**2019 Small Capacity Constraints I
Solicitation Number: CO-00466
Job No.: 19-4526**

**ADDENDUM 1
October 22, 2021**

NOTES	INITIALS	DATE
DESIGNED BY	RK	08/21
REVIEWED BY	JB	08/21
SCALE:	AS SHOWN	
SHEET NO.	GEN-05	
	5 OF 202

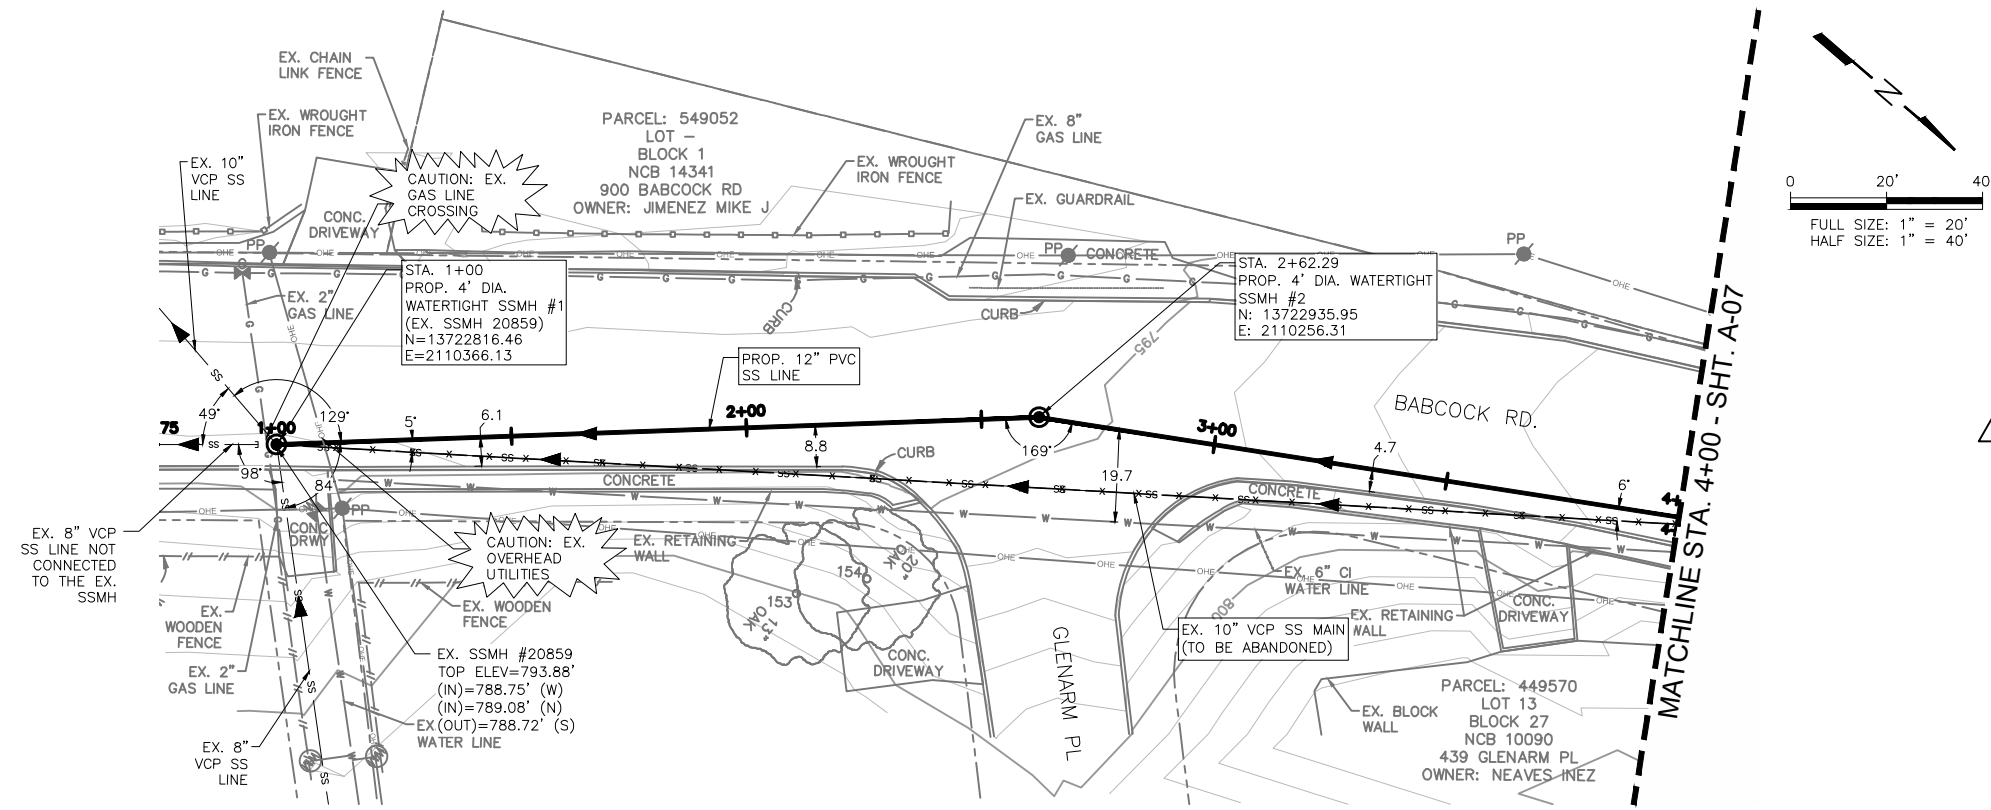
Response: Plan sheets GEN-05 and A-06 are revised and attached to this Addendum to include quantities for concrete encasement as per Specification 858 Concrete Encasement, Cradles, Saddles and Collars. Link to SAWS 2020 Specifications is available in the Table of Contents of the Contract Documents.

- b) New Quantity Line Item for Spec No. 858 Concrete Encasement, Cradles, Saddles and Collars has been added.
2. Plan Sheet GEN-05 – Revised plan sheet includes updates to the estimated quantities per the updated List of Bid Items.
 3. Plan Sheet A-06 – Revised plan sheet includes updated quantities table. The quantities for Line Item Spec No. 858 Concrete Encasement, Cradles, Saddles and Collars has been added.
 4. Plan Sheet G-10 and G-11 – Revised plan sheet includes updated quantities table. The quantities for Line Item Spec No. 511 Trench Repair have been increased.
 5. Plan Sheet G-43A – New plan sheet includes Traffic Control Plans.
 6. Refer to Specification 804 Excavation, Trenching and Backfill, Detail DD-804-01 for the maximum limits of pay for pavement replacement. Link to SAWS 2020 Specifications is available in the Table of Contents of the Contract Documents.

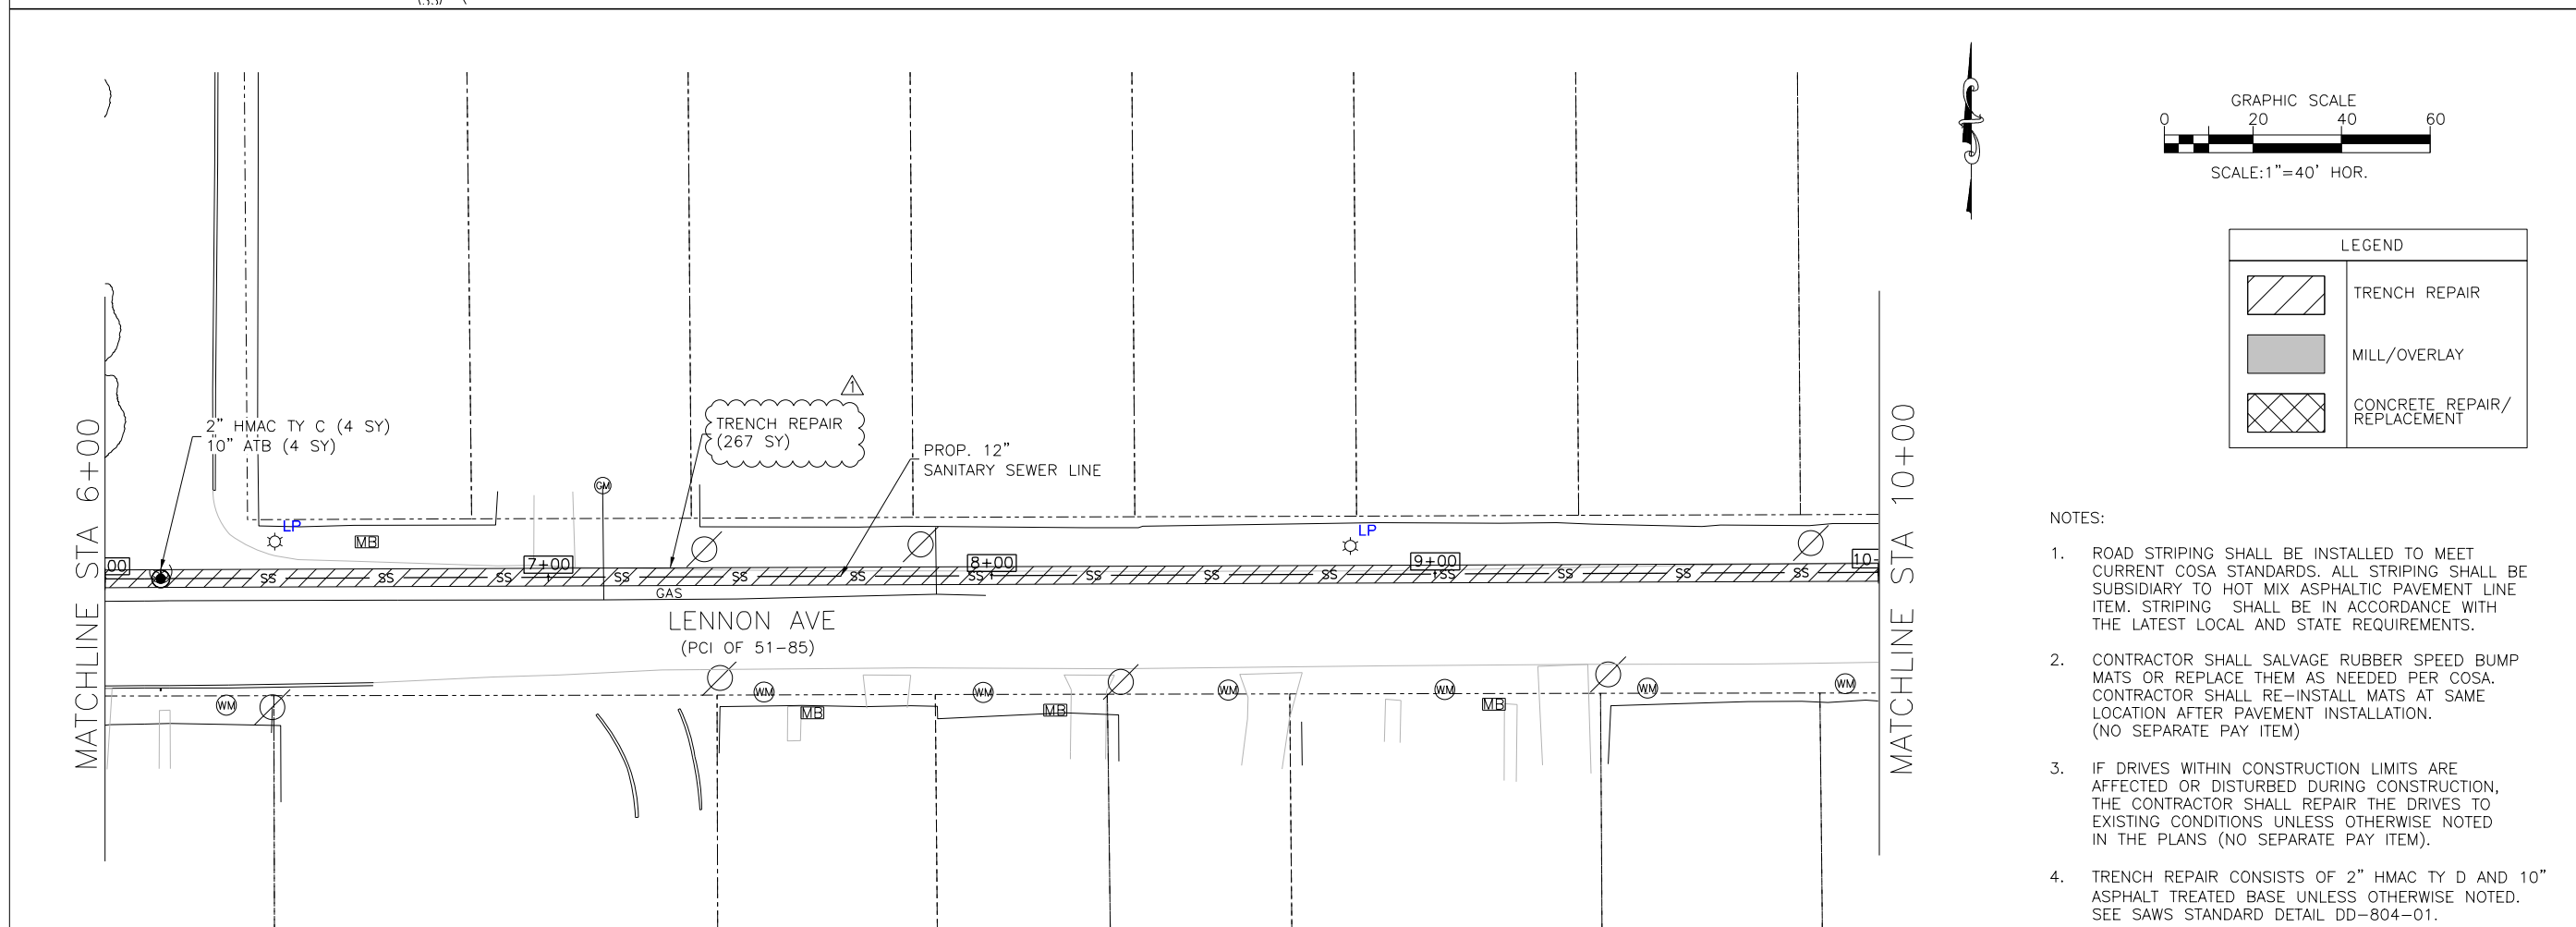
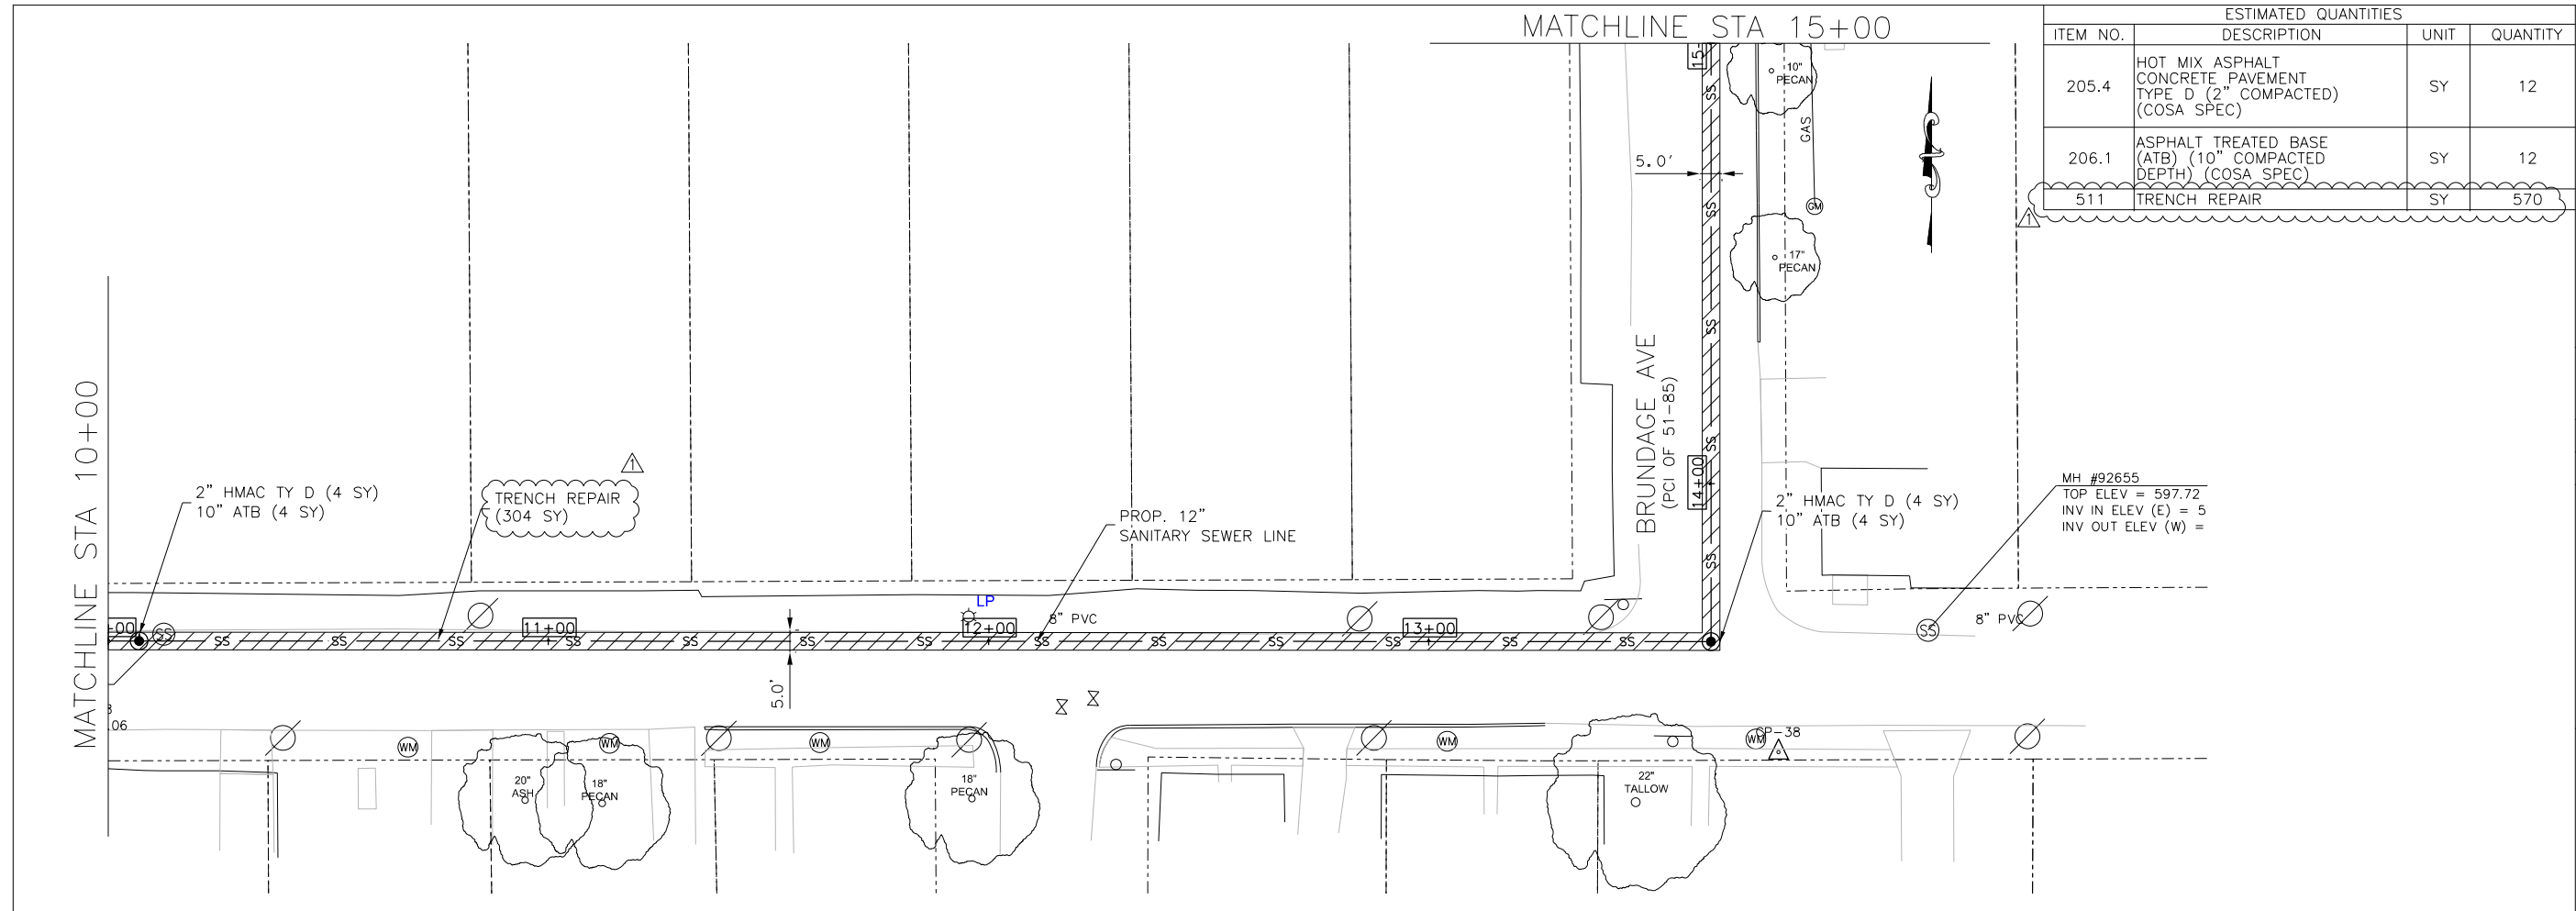
1. Remove the following sheets dated 9/23/21 and replace with the attached sheets dated 10/21/2021:
 - a. Sheet GEN-05 (5 of 202) Overall Quantities Tables
 - b. Sheet A-06 (12 of 202) Babcock Road Sewerline Plan and Profile Sta. 1+00 to Sta. 4+00
 - c. Sheet G-10 (115 of 202) Piedmont And E. Southcross Pavement Plan Sheet 1 of 6.
 - d. Sheet G-11 (116 of 202) Piedmont And E. Southcross Pavement Plan Sheet 2 of 6.
2. A new plan sheet G-43A (148A of 202) Piedmont And E. Southcross Traffic Control Plan Phase I dated 10/21/21 is added to the project.
